Department of Energy

YUCCA MOUNTAIN – REQUEST FOR ADDITIONAL INFORMATION (RAI) –VOLUME 2, CHAPTER 2.1.1.1 SECOND SET (DEPARTMENT OF ENERGY’S SAFETY ANALYSIS REPORT SECTIONS 1.1.4, 1.1.5, and 1.3.4) – Site Description

RAI Volume 2, Chapter 2.1.1.1, Second Set, Number 3:

RAI: 2.2.1.1.1-2-003

Figure 1. Schematic Diagram Showing Geometric Distance from the Edge of the Fault Damage Zone (Taken as a Plane) to Closest Point on Waste Package

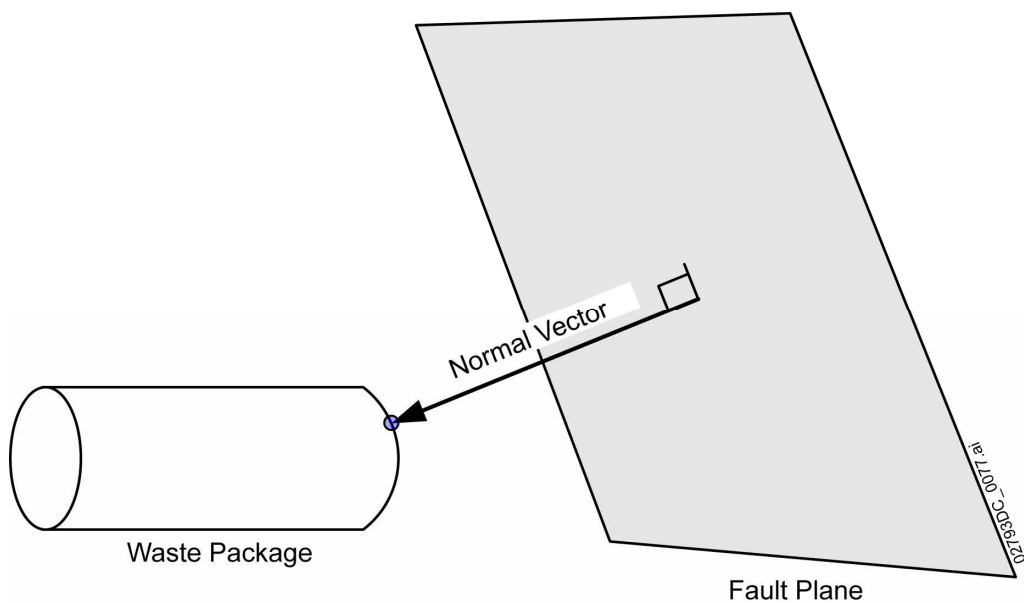
- e. **RAI Volume 2, Chapter 2.1.1.1, Second Set, Number 3, Figures on Page 13 of 13:** Clarify how the standoff distances from fault and fault zones to the edges of an emplacement drift or to ITS and ITWI surface facilities are calculated to ensure that the shortest standoff distance is calculated in the context of the three-dimensional setting and not just in a simplified two-dimensional setting.

To address the preclosure safety requirement of PSC-25 for faults in the subsurface, the standoff is measured as the shortest geometric distance from the fault damage zone (defined in Section 1.2.1 of this response) or its projection to a point on any adjacent waste package. Figure 2 of the original response depicts the standoff distance in an emplacement drift for a simple case and was intended for illustrative purposes only and not to provide a definitive methodology for measurement. The figure was also not meant to suggest a simple two-dimensional measurement along the tunnel axis.

To ensure that the shortest standoff distance is calculated in this case, the measurement of the standoff distance can be accomplished in three-dimensional space using plane geometry by representing the edge of the fault damage zone as a plane (e.g., measured in terms of strike and dip from the surface in the emplacement drift), as illustrated in Figure 1. Computing the normal to the plane using a three-dimensional coordinate system and identifying the closest point on the waste package planned for emplacement near the fault, the minimum distance can be computed between a fault plane defined as $ax + by + cz + d = 0$ and a point $p = (x_1, y_1, z_1)$ using the following equation:

where D is the minimum distance between an identified point on the waste package and the fault. To compute the absolute shortest distance (i.e., the global minimum) as a basis for the standoff distance, it may be necessary to examine several points on the waste package. This computation process can be automated in a simple computer code or calculated by hand for several points on the waste package until the global minimum is identified as a basis for the subject standoff criterion. The actual process will be described in future operational procedures.

Figure 2. Schematic Diagram Showing Variables for ITS Surface Structure Standoff Distance Using 1:1 Approach

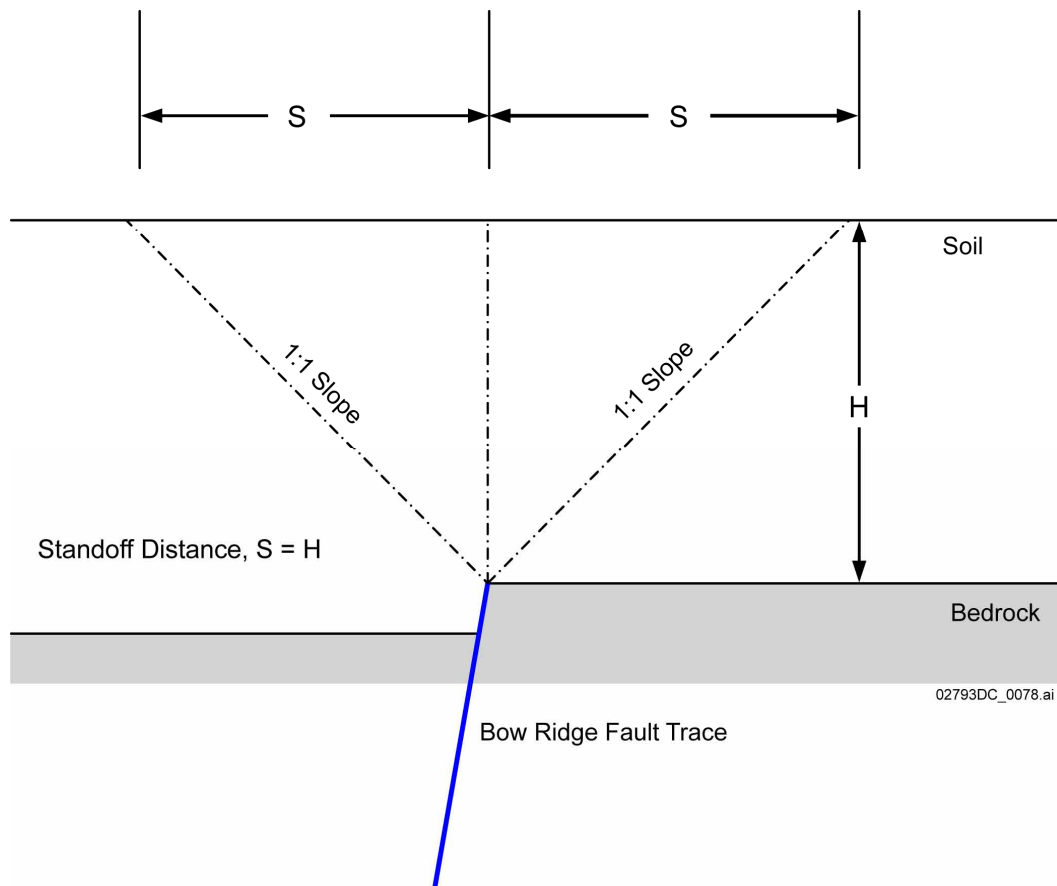
- c. **RAI Volume 2, Chapter 2.1.1.1, Second Set, Number 3, Section 1.4.1, Page 9 of 13:** Clarify the criteria and their technical bases to select a standoff distance to significant displacement (e.g., Bow Ridge Fault or other faults at the surface GROA). As an example, clarify the technical bases to relocate aging pads 17P and 17R to about 300 feet east of the reinterpreted location of the Bow Ridge fault (Orrell 2007).

A standoff distance for the aging pads from the Bow Ridge Fault is established based on the characteristics of this fault and employs a straightforward rule to define a standoff that allows for some variation in the location of the fault and of the rupture zone at the surface. The aging pads are presently located over 100 m from the fault trace to ensure that the standoff distance is met with sufficient margin. In more detail, the standoff criterion for the ITS aging pads is implemented by defining a 1:1 slope from the location of the fault trace at the bedrock surface projected upward through the local soils to the surface, as shown in Figure 2. The standoff is defined for a normal fault, with the understanding that the fault rupture through the soil will initially trend along the orientation of the expected fault surface and then will curve toward the vertical after some distance. This behavior and uncertainty in location of the fault is reasonably captured by the 1:1 slope defining the standoff. For this criterion, the horizontal standoff distance

from either side of the bedrock fault trace is equal to the depth of soil at the location of concern. From an examination of borings in proximity to the fault in the aging pad area, the maximum depth of soil is about 49 m (162 ft) (Table 1). Use of this maximum soil depth with the 1:1 standoff approach results in a 49 m standoff distance from the Bow Ridge Fault bedrock trace at the aging pad location.

Figure 5. Revised Illustration of the 60 Meter Fault Standoff Distance of a Waste Package from a Quaternary Fault with Potential for Significant Displacement

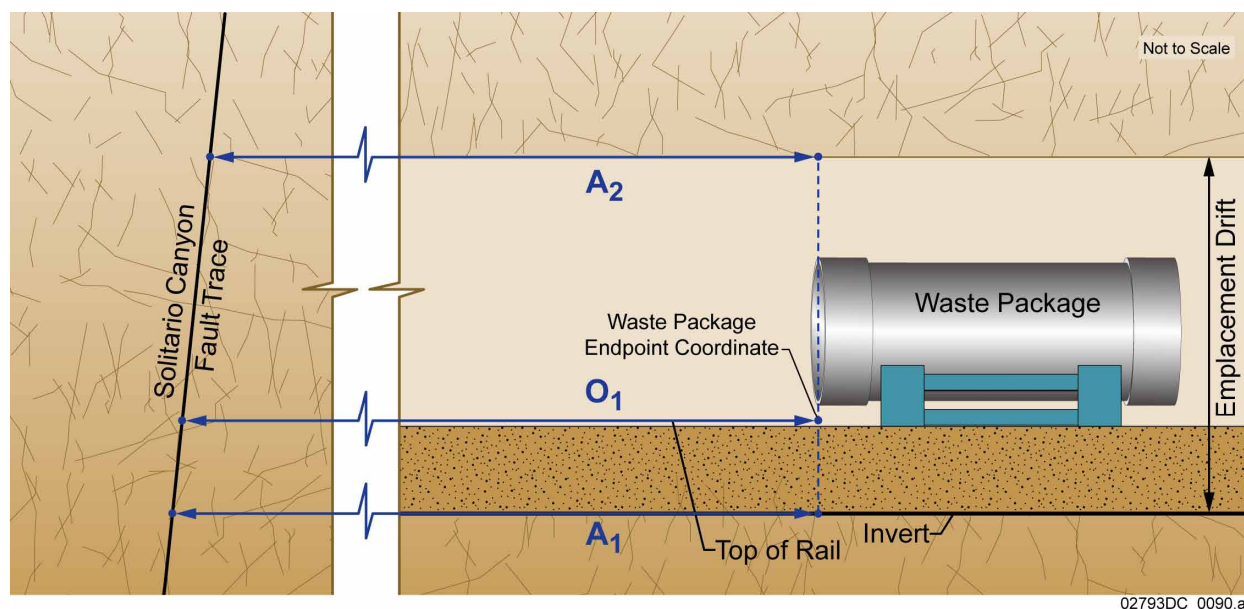
- a. **RAI Volume 2, Chapter 2.1.1.1, Second Set, Number 3, Section 1.4.1, Page 9 of 13:** Clarify the criteria and technical bases to select a 60 m standoff distance from an emplacement drift waste package end point coordinate (WPEC) to a Quaternary fault of significant displacement such as the Solitario Canyon Fault.

- d. **RAI Volume 2, Chapter 2.1.1.1, Second Set, Number 3, Section 1.4.2, Paragraph 2, Page 9 of 13; ibid Section 1.4.2, Paragraph 2, Page 9 of 13; ibid, Figures on pages 13 of 13:** Clarify by explaining the technical basis for why the standoff distance is measured from the centerline (plane) of some fault zones and from the outer edge of the other fault zones.

In implementing design control parameter 01-05, the closest approach of the trace of a Quaternary fault with potential for significant displacement to any underground opening in the subsurface GROA (including access mains) exceeds 60 m (197 ft) based on the layout design (BSC 2003, Section 7.1.3). As the waste emplacement is typically located an additional 60 m (197 ft) to the interior away from the access mains, as measured perpendicular to the access main (and away from the Solitario Canyon and Bow Ridge Faults) (e.g., see SAR Figure 1.3.3-34), the design provides a total minimum separation of at least 120 m (395 ft) from a waste package endpoint coordinate (WPEC) to the Solitario Canyon Fault trace.

The 60 m standoff distance of emplacement drifts from a Quaternary fault with potential for significant displacement, in accordance with design control parameter 01-05, is measured in a horizontal plane at the emplacement level. For this distance measurement, the edge of any emplaced waste package (i.e., the WPEC) is delineated as the edge of the emplacement area. As a clarification to the original RAI response, the 60 m (197 ft) fault standoff distance is measured in the original layout calculation as the shortest distance from the emplacement drift’s WPEC (located horizontally at the top of rail) to the main fault trace projected to the elevation of the emplacement drift (line O_1 in Figure 5). A more comprehensive method for this measurement has been recently identified and used to confirm the standoff distance (as described in the original response to RAI 2.2.1.1.1-2-003), which involves taking two such distance measurements: one at the plane of the emplacement drift invert (base of excavation) elevation and a second measurement at the plane of the emplacement drift crown, with the shorter of the two distances used for compliance confirmation (i.e., the shorter of the two lines A_1 and A_2 in Figure 5). A revised figure showing both these methods is attached (Figure 5). As the orientation of both the Solitario Canyon and the Bow Ridge Faults (i.e., the strike) is approximately parallel to the edge of the subsurface GROA, the latter method accounts for fault dip and thereby provides a minimum distance with sufficient accuracy for the postclosure requirement and is planned to be used for operations. Further, significant margin exists for the standoff requirement for the closest approach of this type of fault to the emplacement area. The Solitario Canyon Fault, which has the closest approach to Panel 4, as described in Section 1.1, provides a total minimum separation of the waste package endpoint from the Solitario Canyon Fault trace of at least 120 m (395 ft).

NOTE: Figure supersedes Figure 1 of original response to RAI 2.2.1.1.1-2-003.

Figure 6. Idealized Cross-Section of a Tunnel Geology to Illustrate Difference Between a Fault Damage Zone and a Fault Zone of Influence

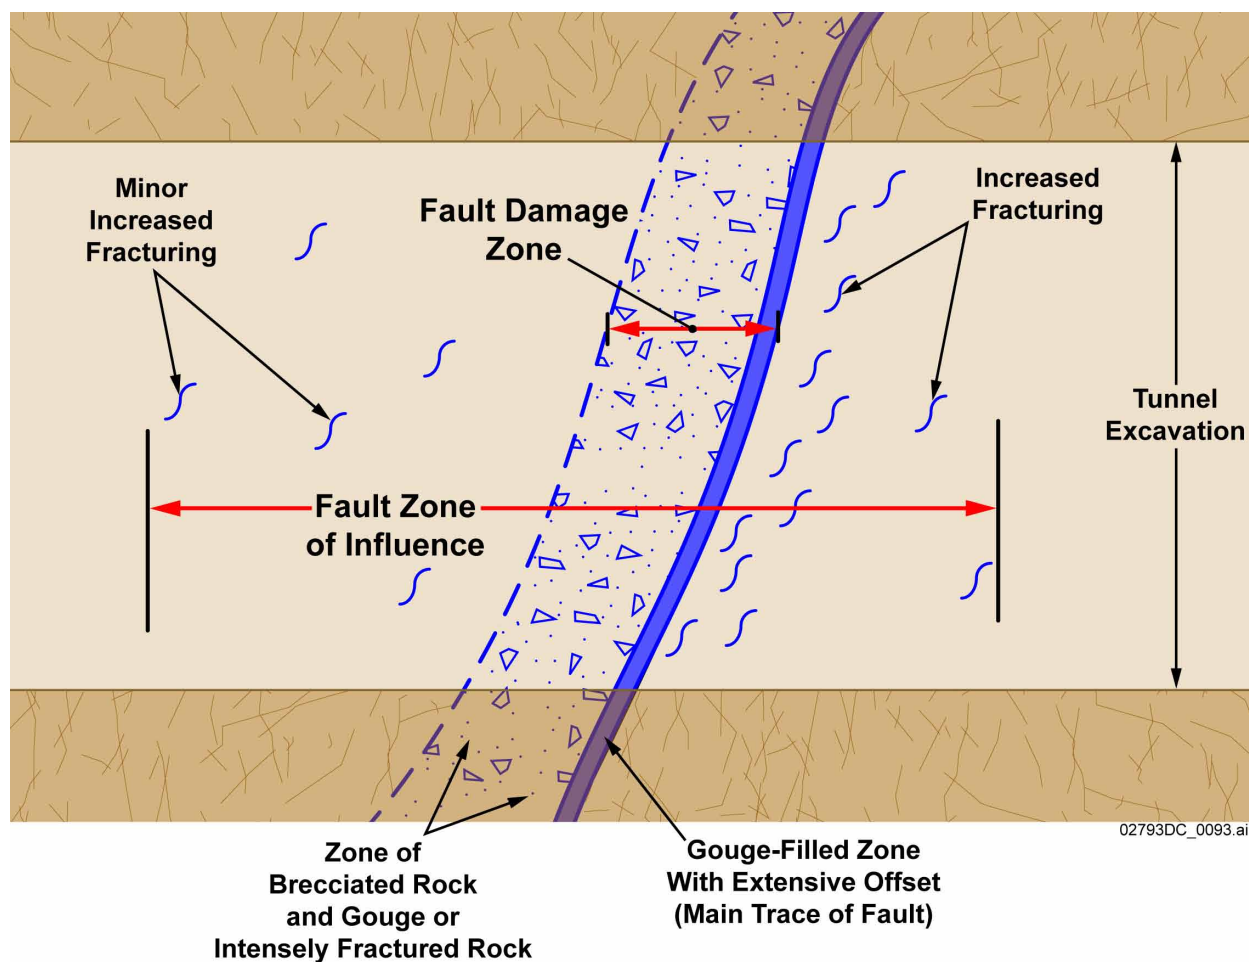
- a. **RAI Volume 2, Chapter 2.1.1.1, Second Set, Number 3, Section 1.2.3, Paragraph 2, Line 5, Page 6 of 13:** Clarify the definition and criteria of a fault damage zone and of a fault zone of influence for the purposes of

standoff and clarify and quantify the criteria of narrow and wide fault damage zones.

For the determination of a standoff distance, a “fault zone of influence” is not identical to a “fault damage zone.” A fault zone of influence is a zone around the principal fault plane in which fracture intensity (defined as the number of fractures per unit of length) is higher than in the surrounding rock or in which some other parameter (such as fracture orientation) changes in response to the presence of the fault, as described in the license application (SAR Section 1.1.5.1.3.2). This is illustrated in Figure 6. As related to preclosure safety methodology, a fault damage zone is a zone adjacent to a fault where the hazard of rockfall or fault rupture (which can potentially breach the waste package) is significantly increased from the hazard identified for the overall rock mass around an emplacement drift (the rockfall hazard is addressed in preclosure safety for typical emplacement drift conditions with a bounding approach in which a large rock block controlled by local jointing is considered).

For the purposes of describing the preclosure safety hazard, the term “fault damage zone” is introduced in this response, distinct from a “fault zone of influence” or a “fault zone” (Figure 6). A fault damage zone is defined as a zone of faulting that can represent a potential hazard for breaching a waste package. The extent of a fault damage zone includes zones of intense fracturing with breccia or gouge between the surfaces of the fault as well as zones of intense fracturing (i.e., zones of closely spaced fractures) directly associated with a fault. However, the term does not include zones of rock that are largely intact with some minor additional fractures or minor changes in properties. The definition also does not spatially combine fractures or zones that are widely spaced.
